September 25, 1984

HOPE CREEK GENERATING STATION  
DOCKET NO. 50-354  
POWER SYSTEM BRANCH

Pursuant to discussions with the Power System Branch (PSB), the responses to the FSAR Questions listed in Attachment 1 have been revised and are enclosed for your review and approval (See Attachment 2).

Figure 430.135-1

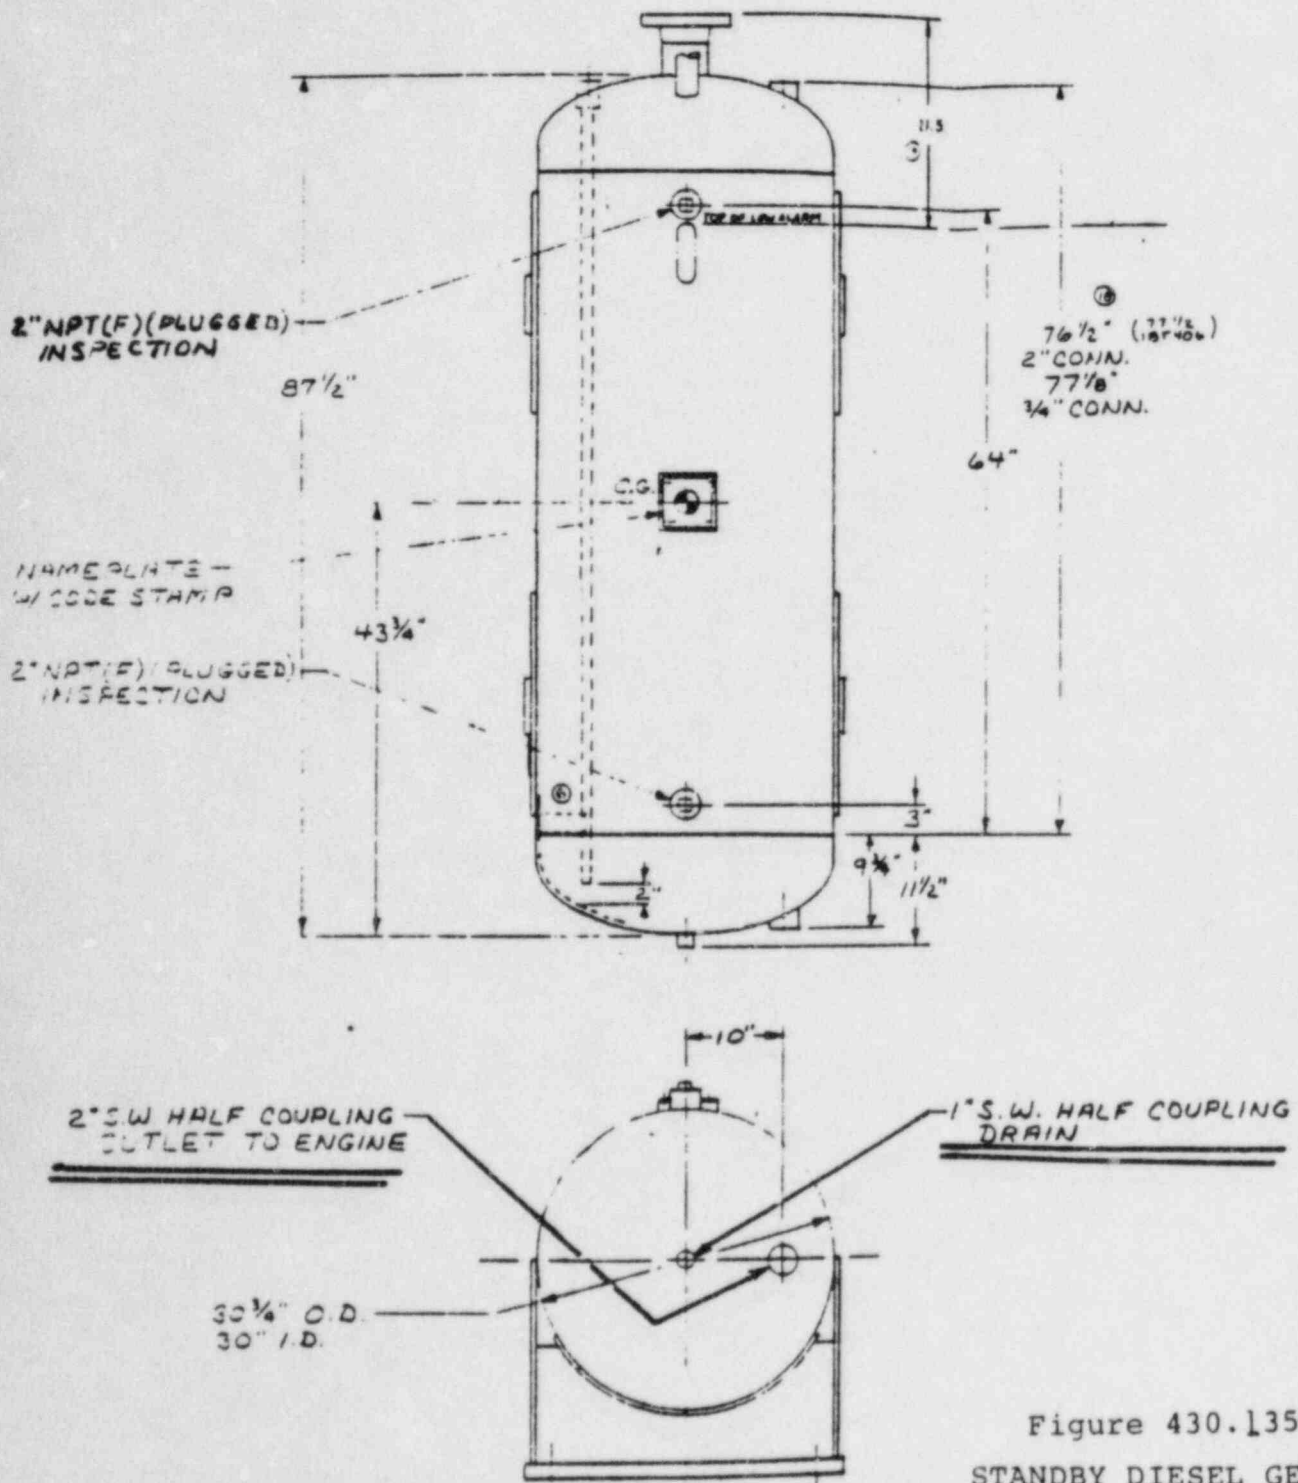
You state in Section 9.5.7.2 of the FSAR and shown in Figure 9.5-27 that lube oil is added to the diesel generator lubricating oil system from a 250 gallon lube oil make-up tank. Provide a discussion on the measures that have been taken to prevent entry of deleterious materials in the lube oil make-up tank. Also discuss what measures have been taken to prevent entry of deleterious materials into the lube oil make-up tank due to operator error during filling operation.

- c. Figure 9.5-27 of the FSAR shows that the diesel generator lube oil make-up tank is provided with an individual fill, vent, and emergency pressure relief vent lines. Indicate where these lines are located (indoor or outdoor) and the height these lines are terminated above finished ground grade. If these lines are located outdoors discuss the provisions made in your design to prevent entrance of water into the make-up tank during adverse environmental conditions, and the tornado missile protection provided.

The lube oil makeup tank bottom is hemispherical. The line to the diesel generator sump is approximately 1.75 inches above the bottom of the dish and is located ten inches off the centerline of the tank, reference figure 430.135-1. Should there be any carry over into the transfer line, it would be trapped in the strainer and/or filter after entering the engine sump.

A normally closed drain valve is provided at the low point of the tank, reference Figures 9.5-27 and 430.135-1. The drain valve will be opened in accordance with plant operating procedures to remove any deleterious sediment, water or other material that may accumulate in the bottom of the tank.
